Federal Register

[Docket No. FAA-2020-0098; Product Identifier 2020-NM-011-AD; Amendment 39-19844; AD 2020-03-20]

Airworthiness Directives; The Boeing Company Airplanes

ACTION: Final rule; request for comments.

Figure 2 to paragraph (g) – AFM – Limitations or Certificate Limitations**Electronics – Global Landing Unit (GLU)****(Required by AD 2020-03-20)**

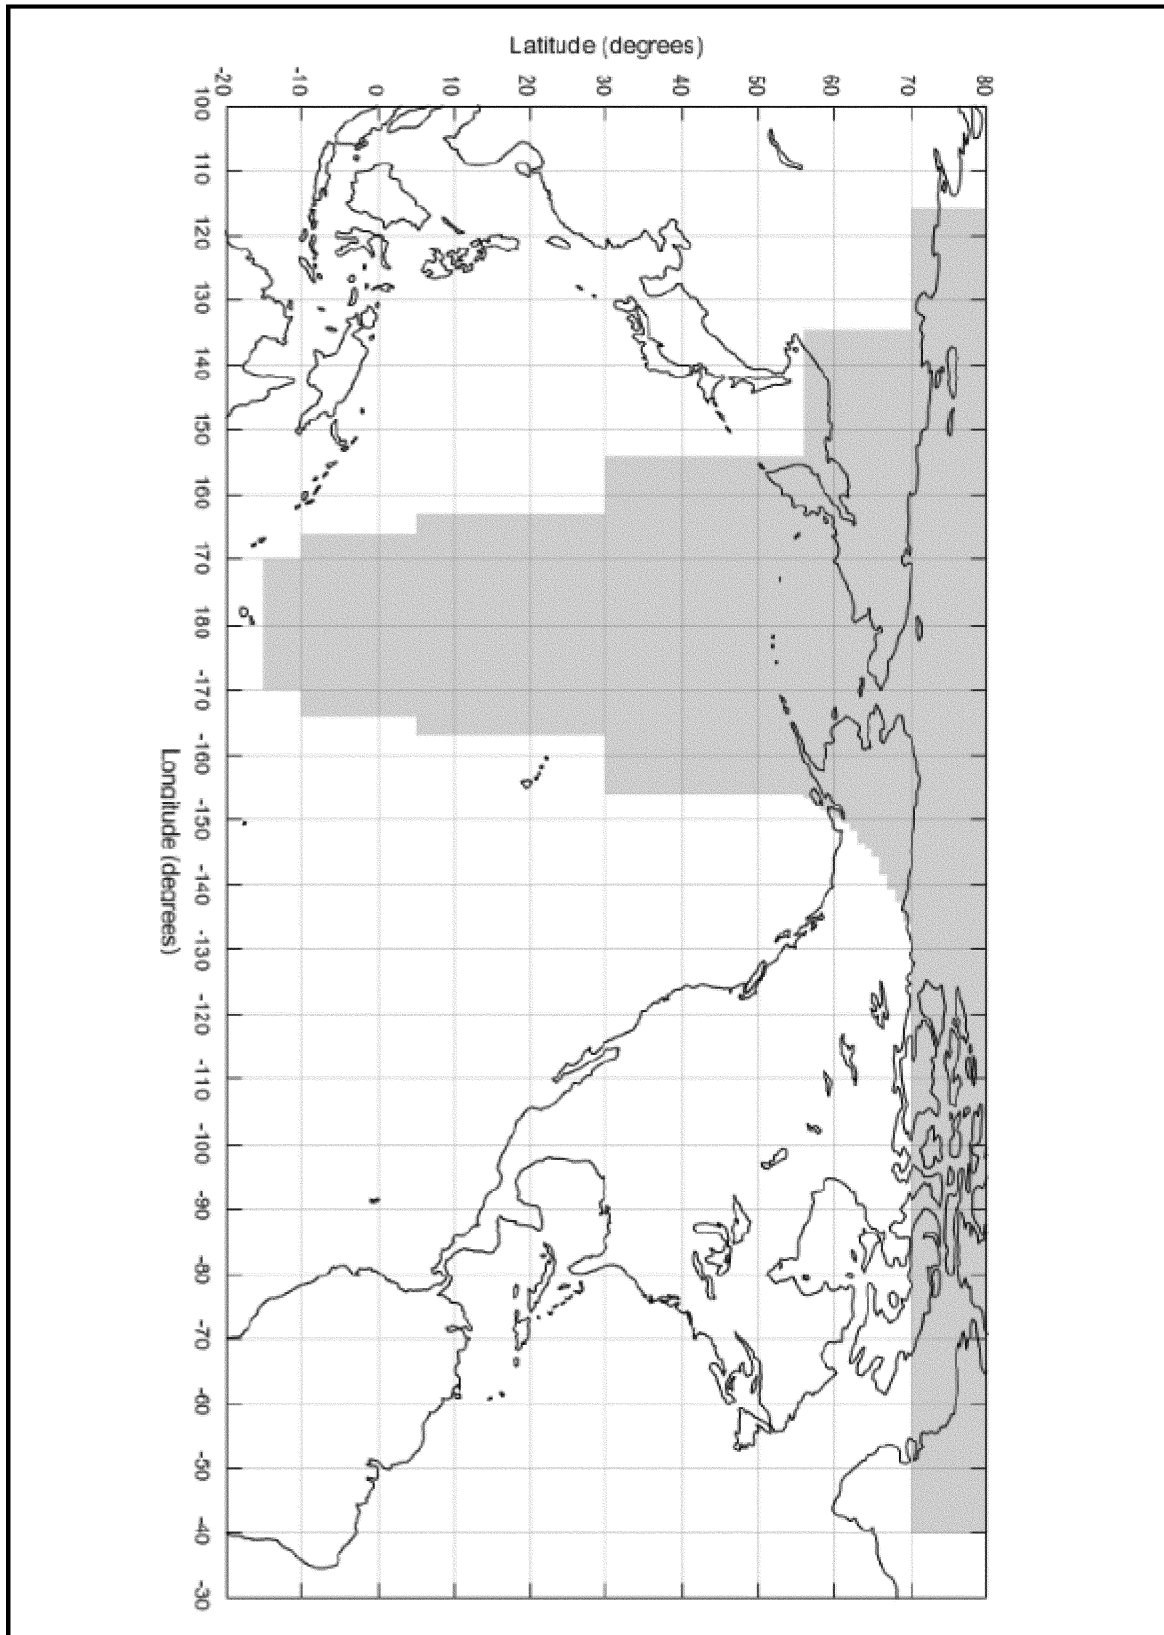
Operations that require less than 0.3 RNP (For example, 0.1, 0.11, 0.15, etc.) in the region identified below are prohibited with GLU-2100 OPS software number COL4D-0087-0002, COL4E-0087-0001, COL48-0087-0700, or COL49-0087-0701 installed.

Exception: Anchorage (PANC) approach procedures that allow less than RNP 0.3 are authorized provided the instructions outlined in the Electronics – Global Landing Unit Section of Normal Procedures Chapter are followed.

Note: Currently, Fairbanks (PAFA) and Anchorage (PANC) are the only airports in the region with an RNP approach that requires better than 0.3 nmi performance.

Region bounded by the following coordinates:
